client	Tice River Homes				location	Ayr			
project	Legacy				marketing name				
#	revisions	date	dwn	chk	#	revisions	date	dwn	chk
1	ISSUED FOR CLIENT REVIEW	23-FEB-18	KK	JM					
2	REVISED PER TRUSS COORDINATION	23-APR-18	LO	JM					
3	REVISED PER ENGINEER COMMENTS & ISSUED FOR PERMIT	20-JUL-18	WU	JM					
5	RE-ISSUE FOR PERMIT	18-OCT-19	ES	ES

model 40-03  
 scale 3/16" = 1'0"  
 project # 17052  
 page **A1**

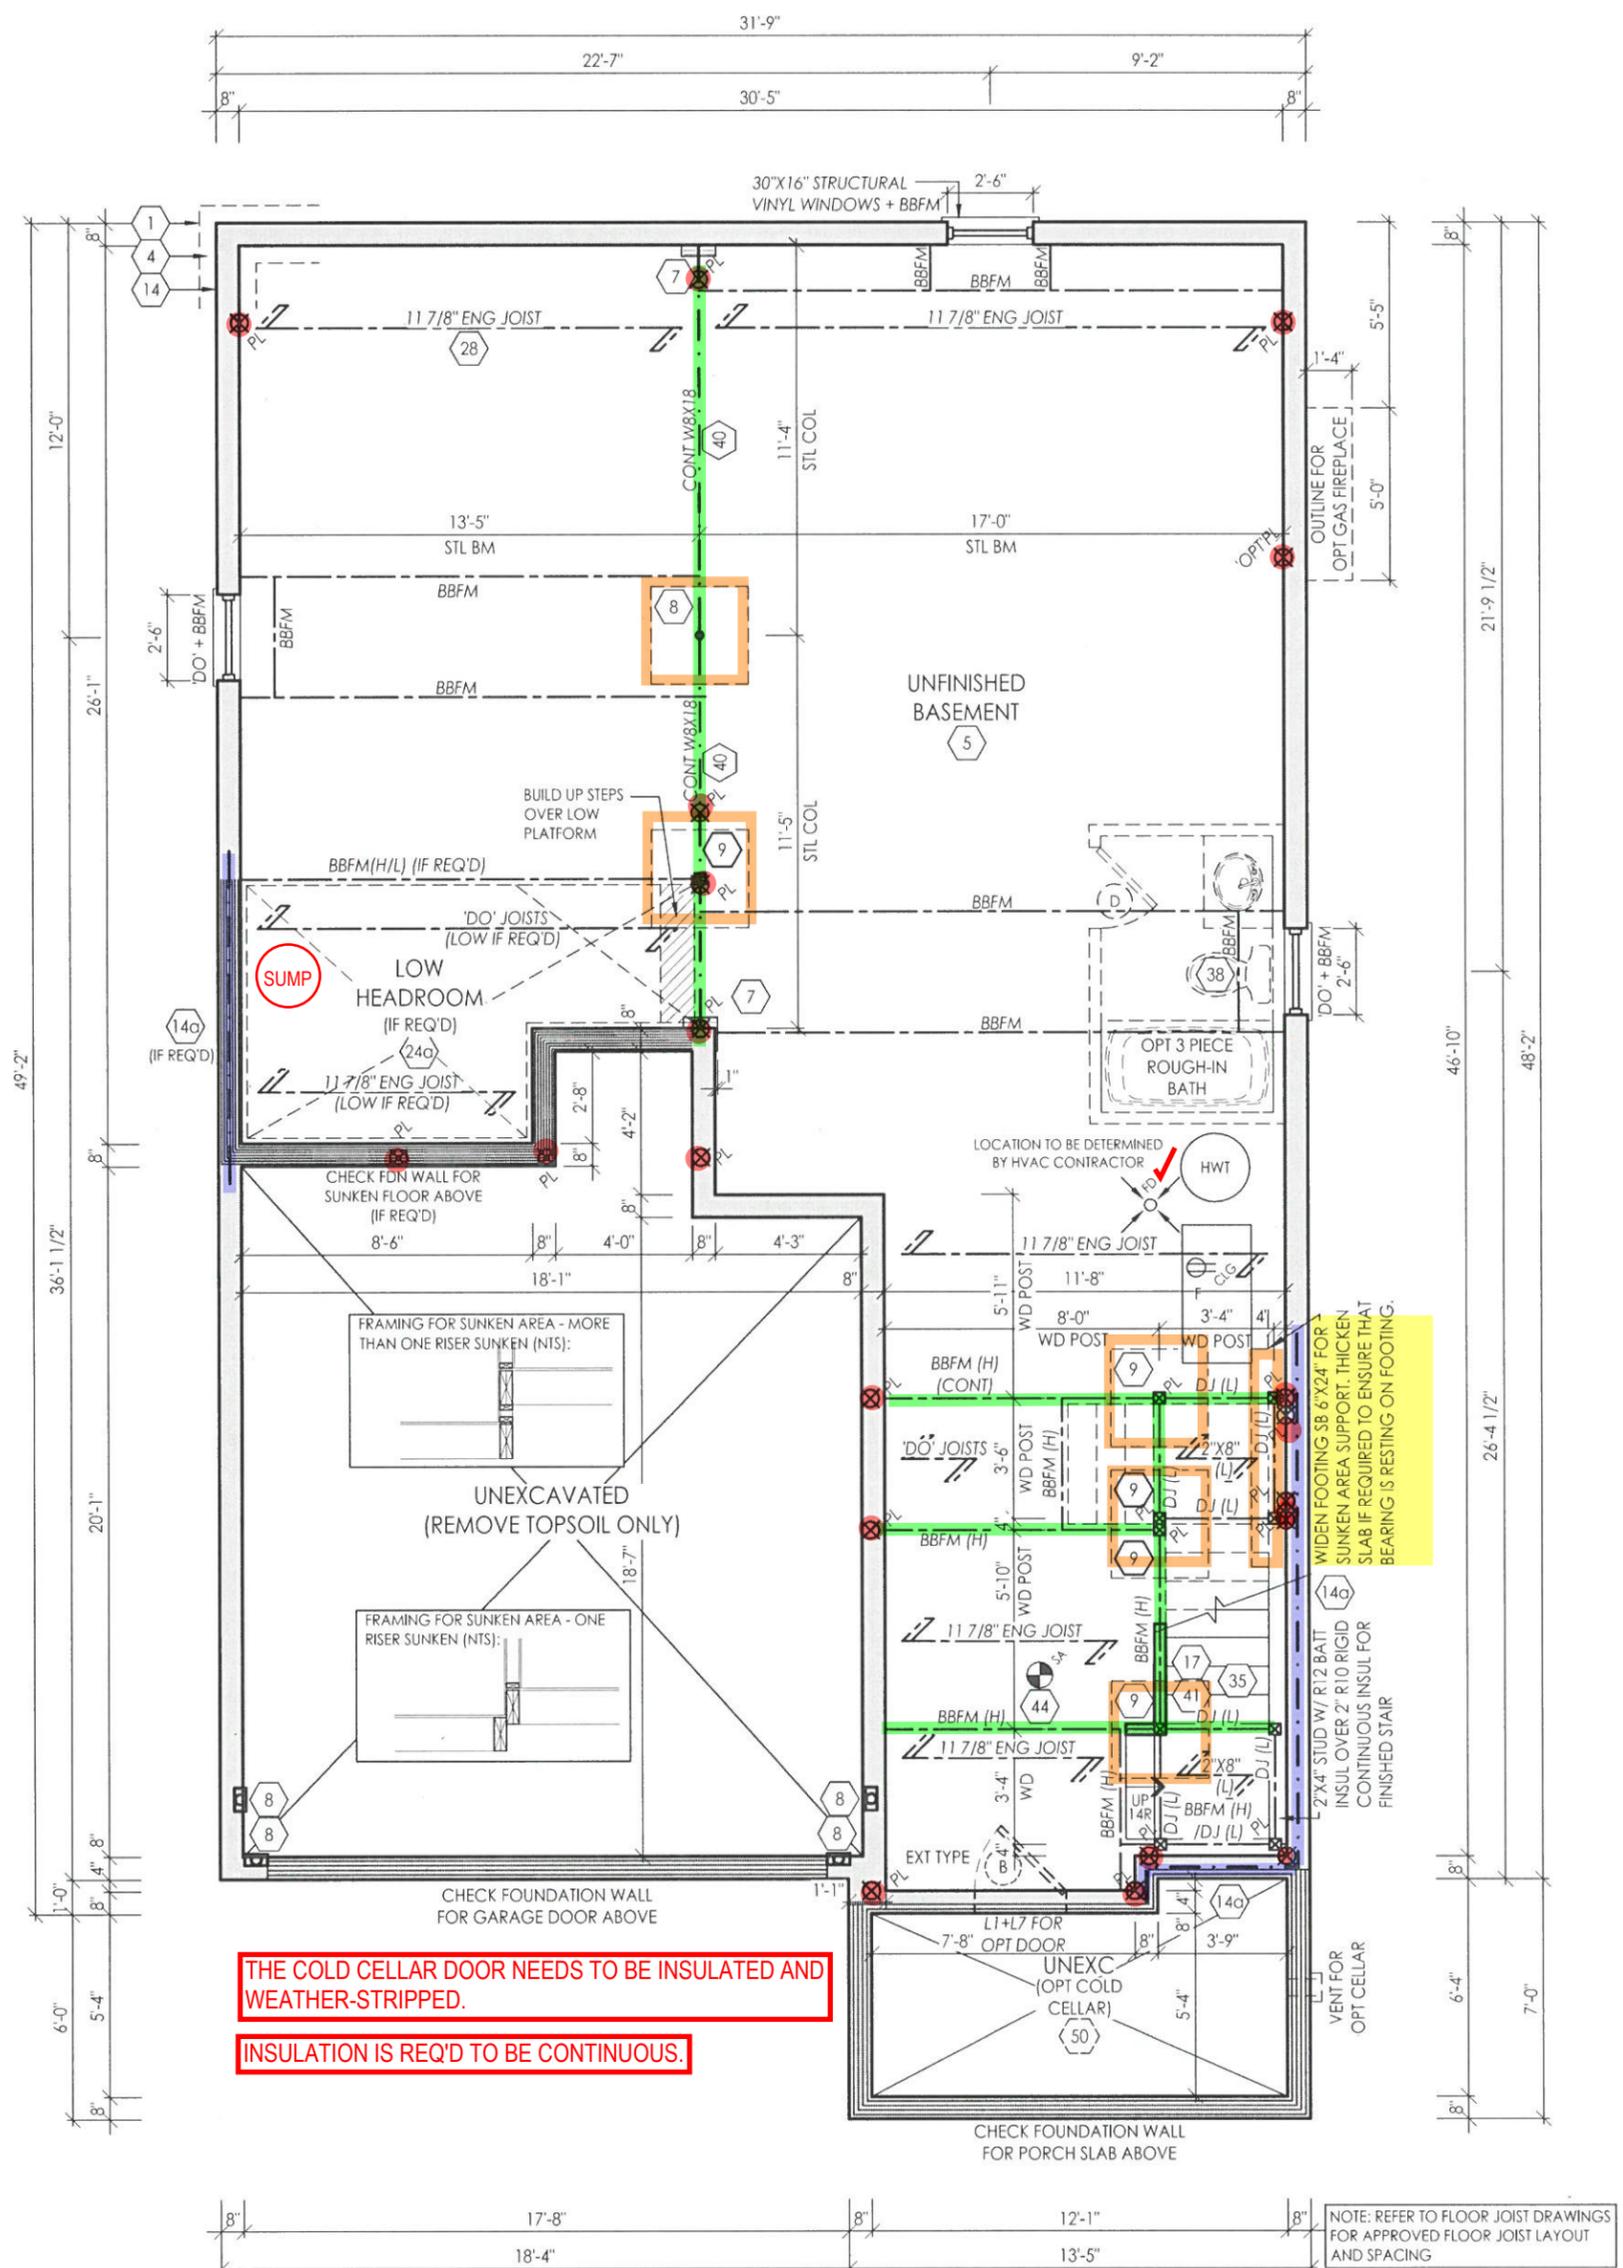
**A SEPARATE BUILDING PERMIT WILL BE REQUIRED TO FINISH THE BASEMENT.**

**THE COLD CELLAR DOOR NEEDS TO BE INSULATED AND WEATHER-STRIPPED.**

**INSULATION IS REQ'D TO BE CONTINUOUS.**

page: **A2**

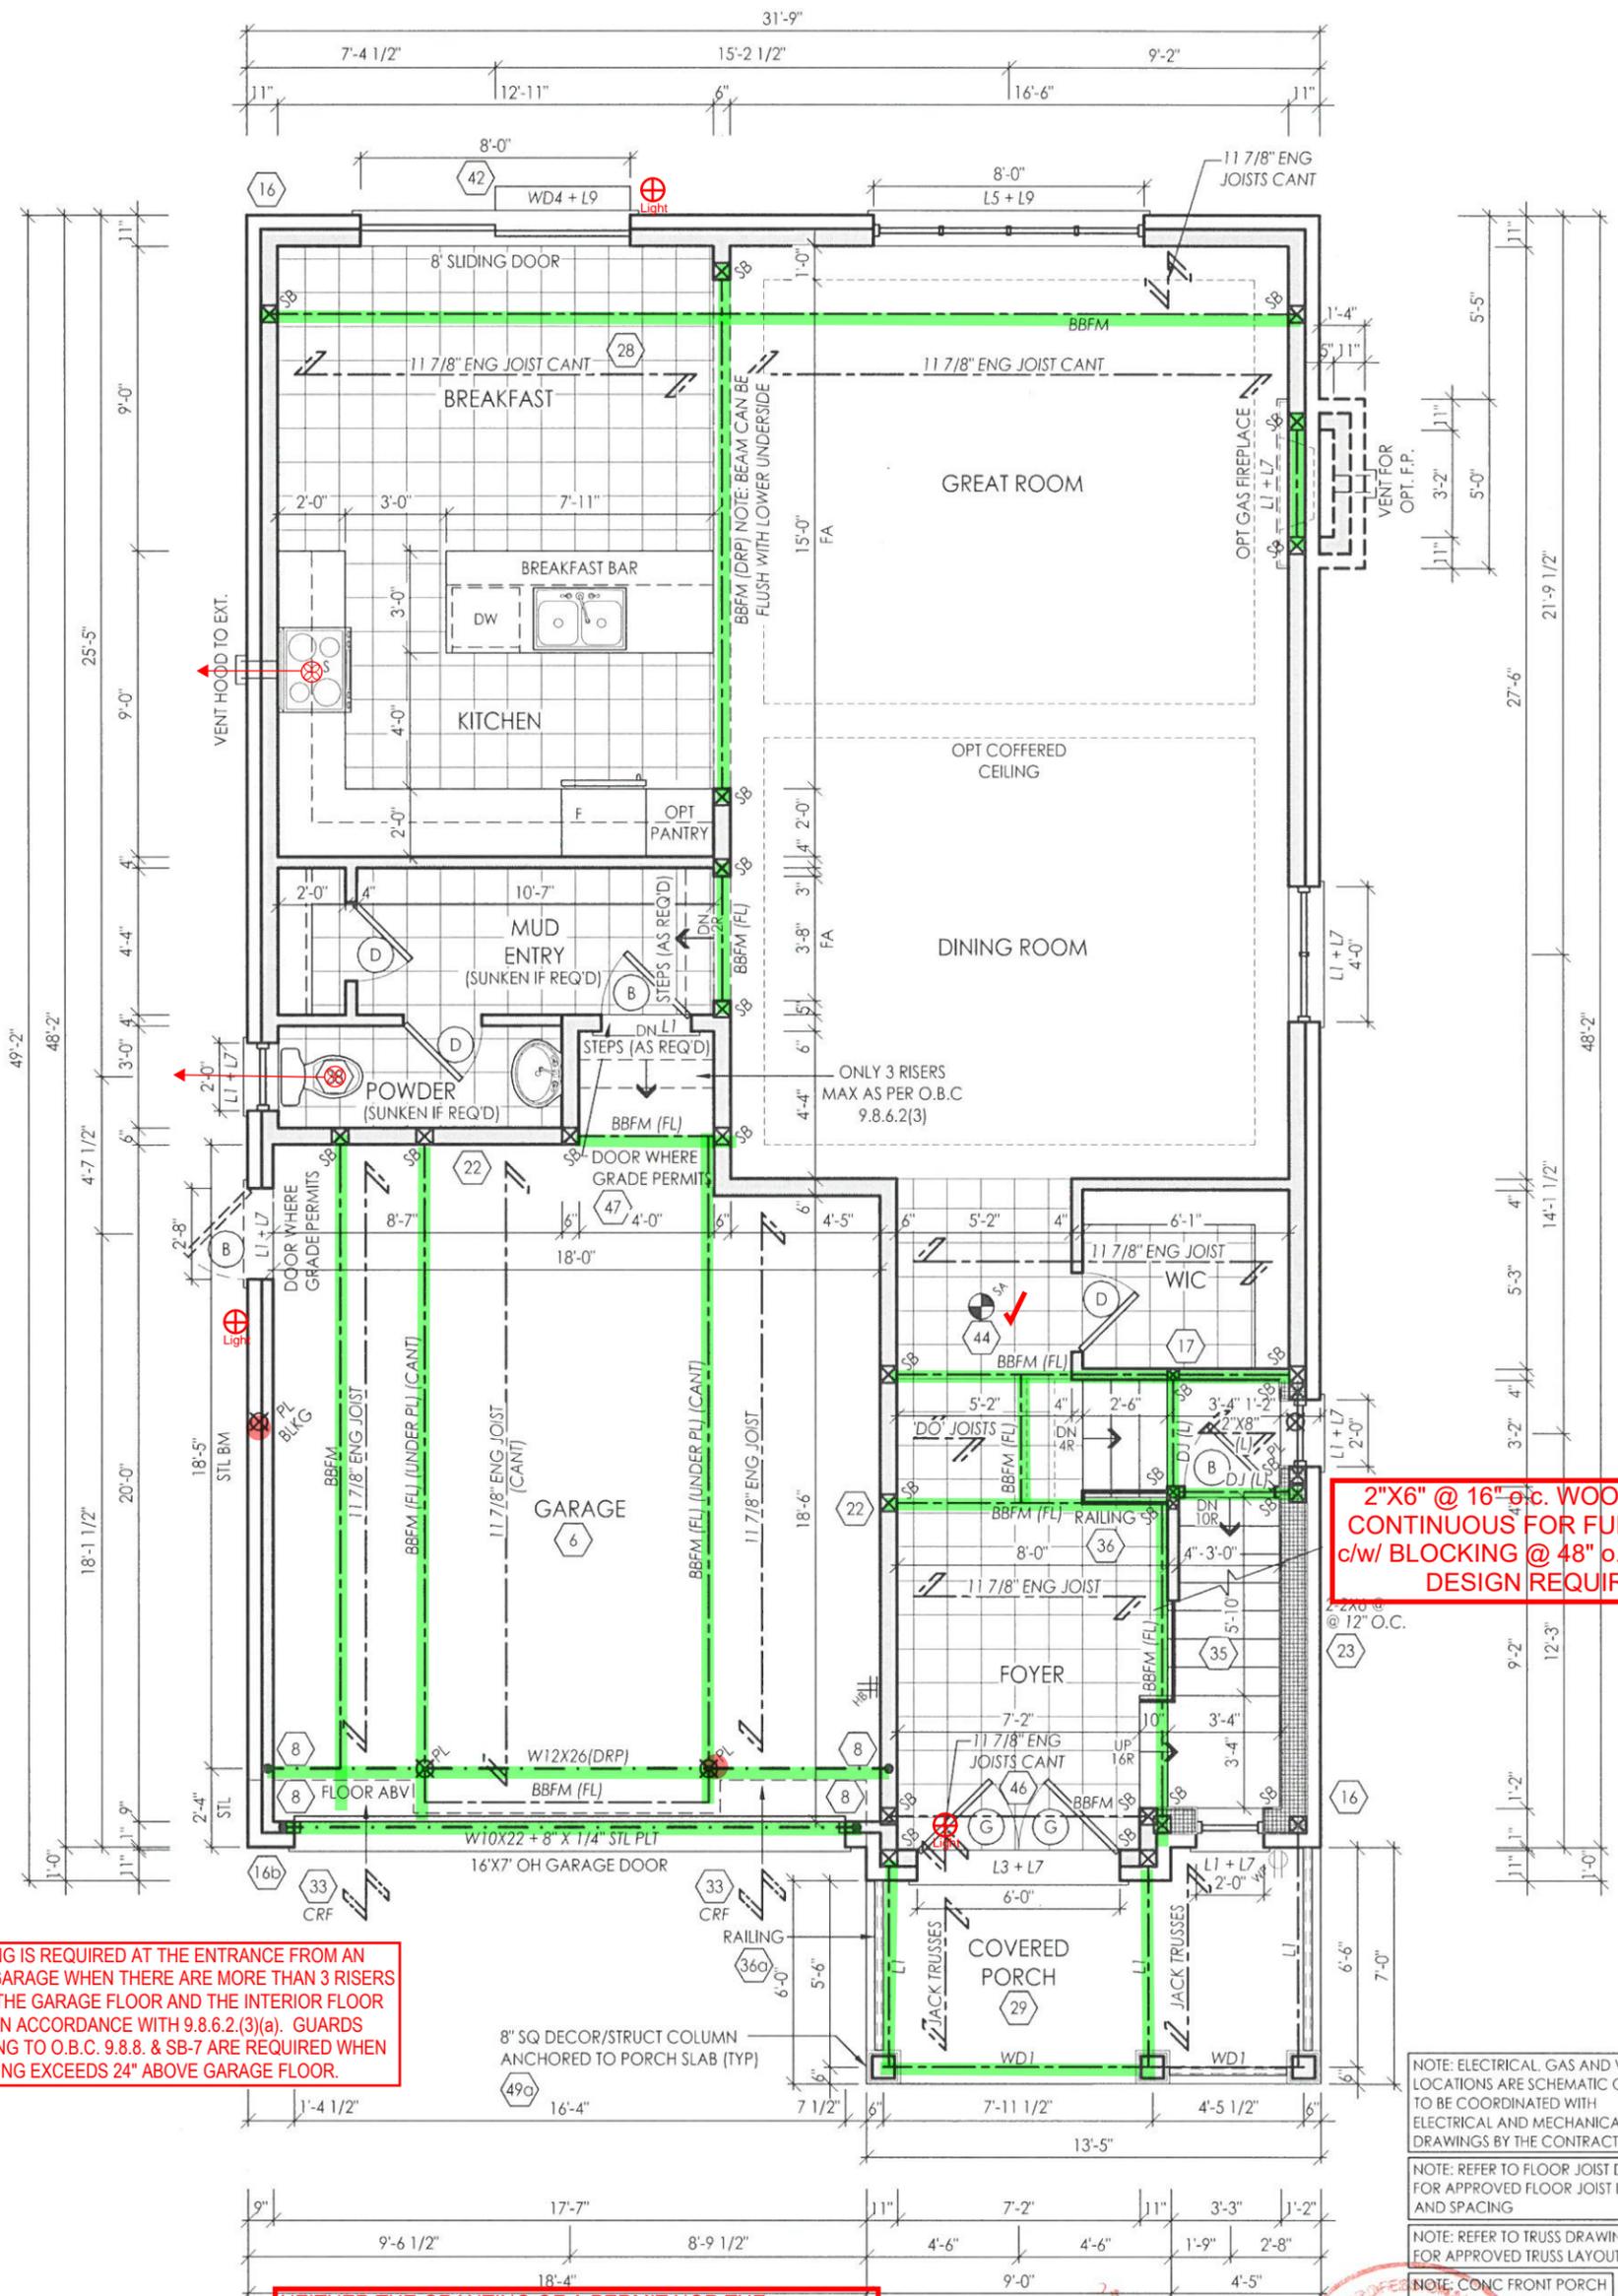
**SMOKE ALARMS WITH VISUAL ALARM ARE REQUIRED ON EACH FLOOR AND IN EACH BEDROOM INCLUDING A SMOKE/CO IN THE HALL THAT SERVICES THE BEDROOM.**

**A LANDING IS REQUIRED AT THE ENTRANCE FROM AN ATTACHED GARAGE WHEN THERE ARE MORE THAN 3 RISERS BETWEEN THE GARAGE FLOOR AND THE INTERIOR FLOOR LEVELS IN ACCORDANCE WITH 9.8.6.2.(3)(a). GUARDS CONFORMING TO O.B.C. 9.8.8. & SB-7 ARE REQUIRED WHEN LANDING EXCEEDS 24\"/>**

page **A3**

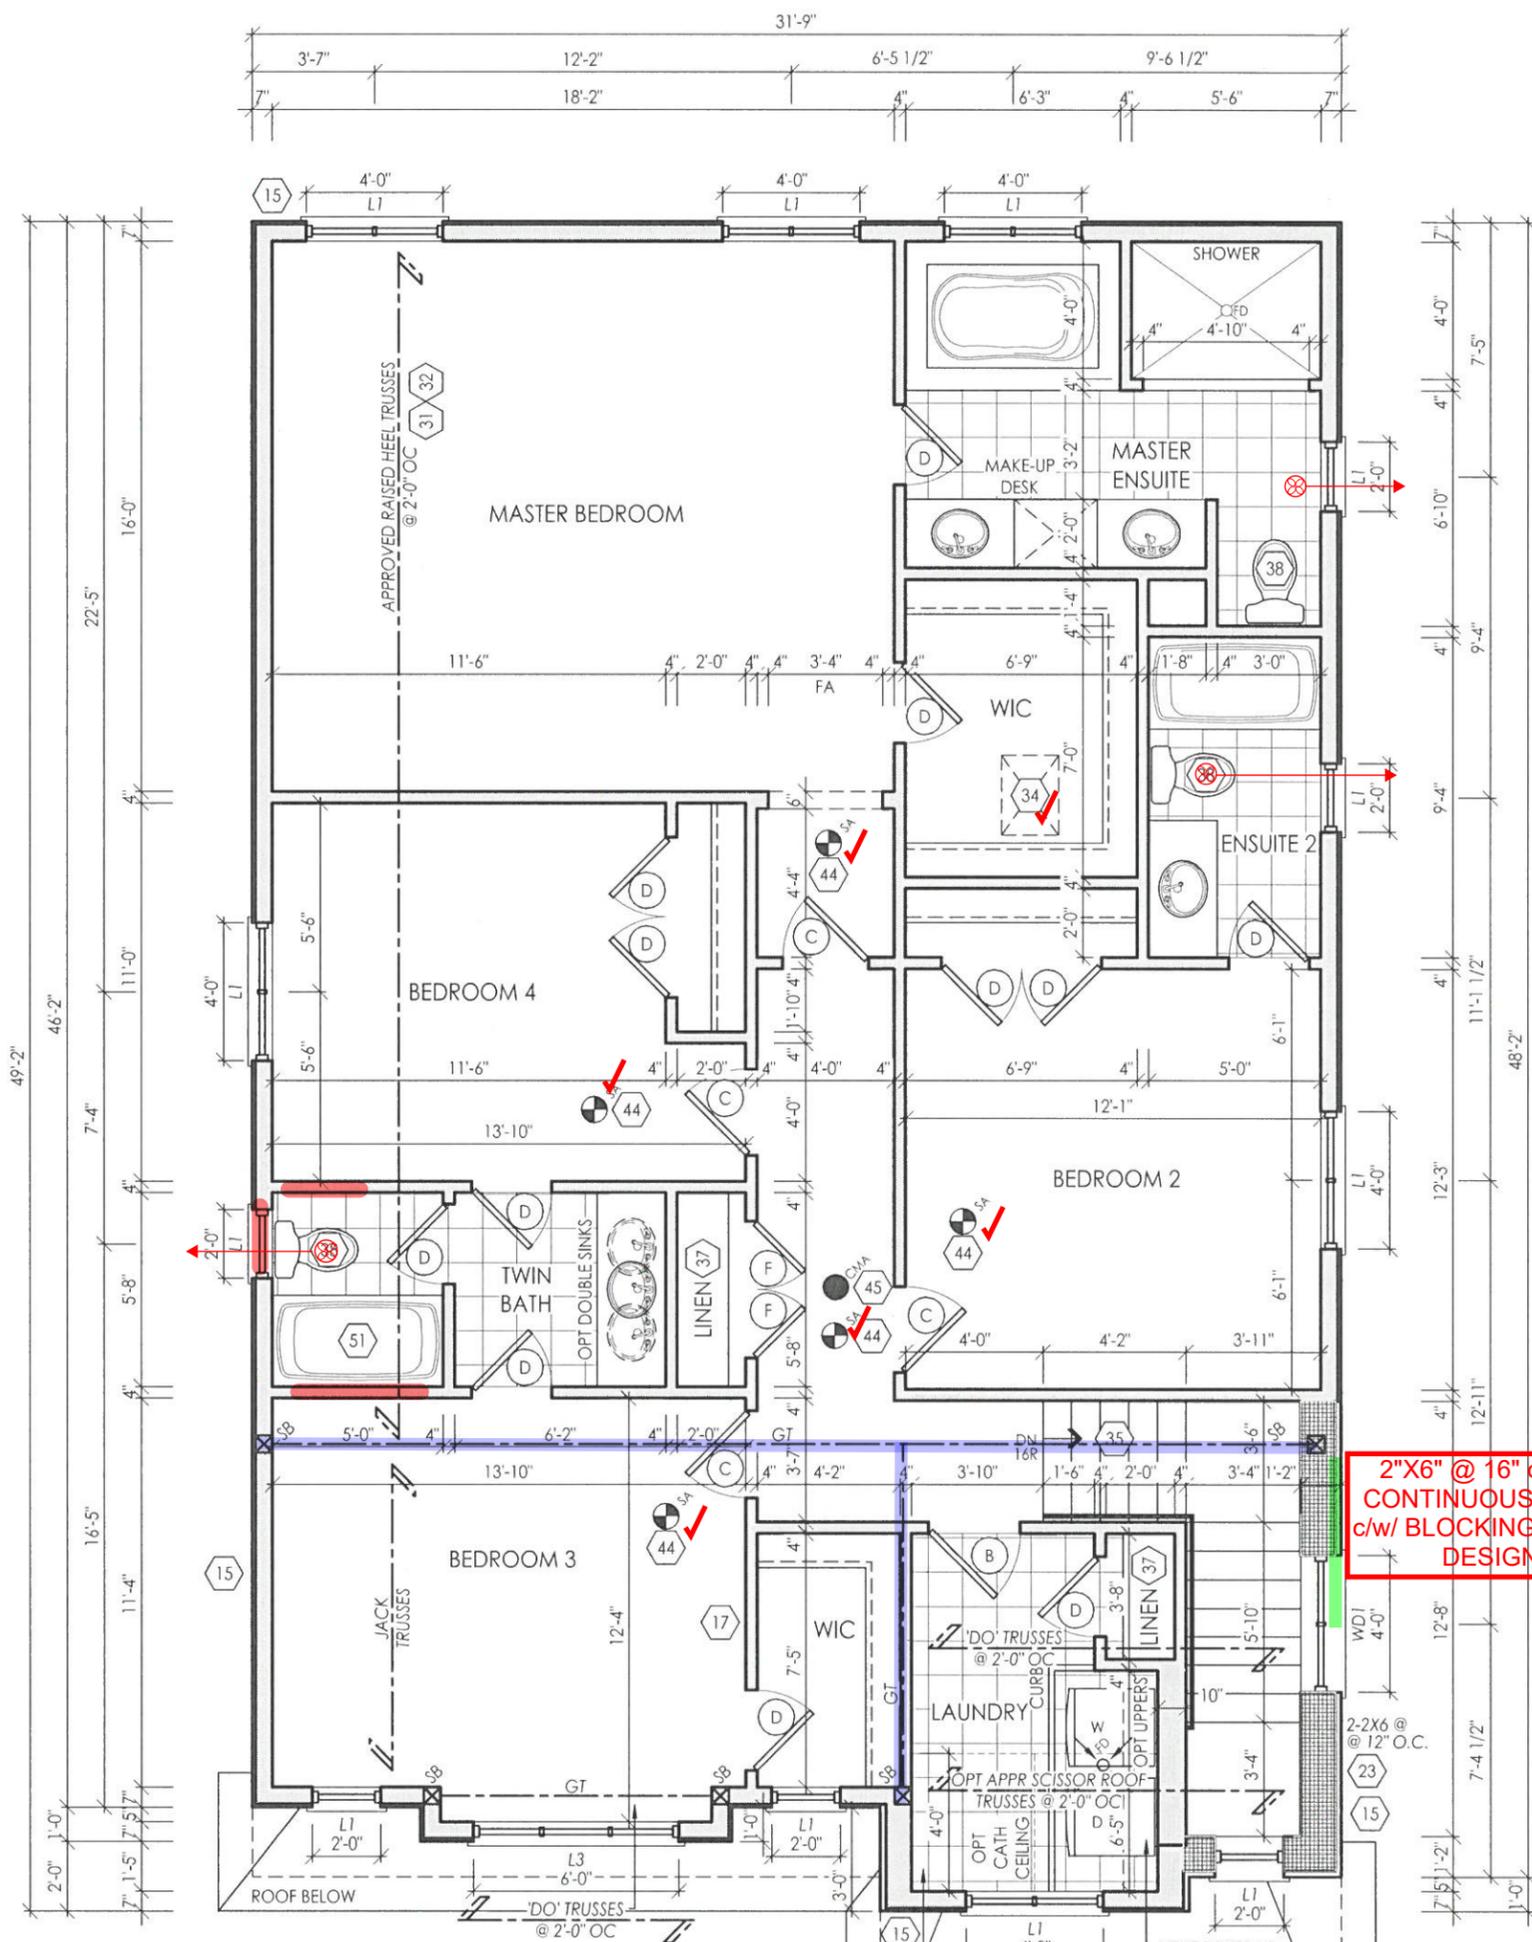
**SMOKE ALARMS WITH VISUAL ALARM ARE REQUIRED ON EACH FLOOR AND IN EACH BEDROOM INCLUDING A SMOKE/CO IN THE HALL THAT SERVICES THE BEDROOM.**

**2"X6" @ 16" o.c. WOOD STUDS CONTINUOUS FOR FULL HEIGHT c/w BLOCKING @ 48" o.c. or P.ENG DESIGN REQUIRED.**

**WINDOW SILL TO ME MINIMUM 2'-11" ABOVE STAIR/LANDING, OR BE PROTECTED BY A GUARD, OR BE DESIGNED TO WITHSTAND THE LOADS.**

**REINFORCEMENT REQUIRED IN MAIN BATHROOM STUD WALLS TO PERMIT THE FUTURE INSTALLATION OF GRAB BARS.**

**AT LEAST 1 WINDOW SHALL PROVIDE AN UNOBSTRUCTED AREA OF 22" X 39" W/ A SILL HEIGHT MAX. 3'-3" ABOVE FINISHED FLOOR & 23'-0" ABOVE GRADE**
